USACE Armor Cap Reassessment of Western Berm

CERCLA Docket No. 06-12-10

San Jacinto River Waste Pits Superfund Site near Pasadena, Harris County, Texas

# Review of Design, Construction and Repair of TCRA Armoring for West Berm of San Jacinto Waste Pits

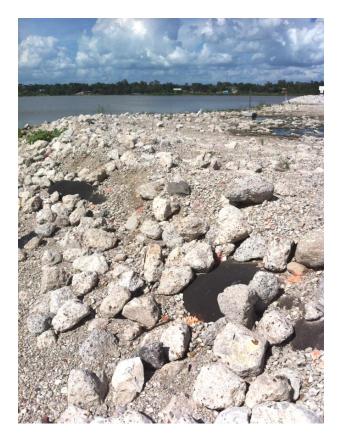
This review of the design and construction of TCRA armoring for west berm of San Jacinto Waste Pits, TX is being conducted to address the performance of the armoring during a recent flood/storm event estimated to be a 10-year return event. Following the event, considerable movement or loss of armor material was discovered as evident in Figures 1, 2, 3 and 4.

Armor caps can be designed in three manners: 1) traditional with a base layer, filter layer and armor layer, 2) a graded armor layer (blended filter-sized stones and armor size stones) over the base layer, and 3) a base layer, geotextiles filter and armor layer. The first option is the common method for shallow marine construction; the second option is becoming a common option for deep water environments with shallow slopes; and the third option is commonly applied on shorelines with moderate to steep slopes. At San Jacinto the armor cap was designed with options 2 and 3 or a combination of options 2 and 3. Cap Configuration A consisted of geotextile placed on the base layer for constructability and then capped with blended armor and filter stones. The filter material also provided a bedding to protect the geotextiles from puncture by armor stone during construction. Cap Configurations B, C, D and E in the Final Removal Action Work Plan, Appendix A: TCRA Technical Specifications (September 2010) do not call for the use of armor stone blended with filter stone. Nevertheless, Figures 1 through 4 show a large quantity of gravels and sand in the Cap B/C, resembling a blended filter.

The armor stone specification is not well specified. The TCRA Technical Specifications, Appendix A (Anchor QEA November 2010) and USA Submittal 10 (Anchor QEA Feb 2011) cite only that 100% of the stones passes 12 inches with no more than 50% passing 6 inches and no more than 4% passing the #200 sieve. The armor stone should have had a specification of no more than 10% passing 2 inches to improve the uniformity and stability. The pictures in Figures 1 through 4 show an excessive quantity of gravel and sand size particles.

The slope of an armored bank should not generally exceed 1V:2H and in an area with overtopping and waves breaking should not exceed 1V:3H. Appropriately, the slope of the west berm was designed to be no more than approximately 1V:3H; however, Figures 2, 3 and 4 show slope sections that appear to be as steep as 1V:1H. The face of the berm shown in these pictures should have been filled with bedding material to ensure that all slopes were no greater than 1V:3H where high velocities, waves and overtopping may occur.
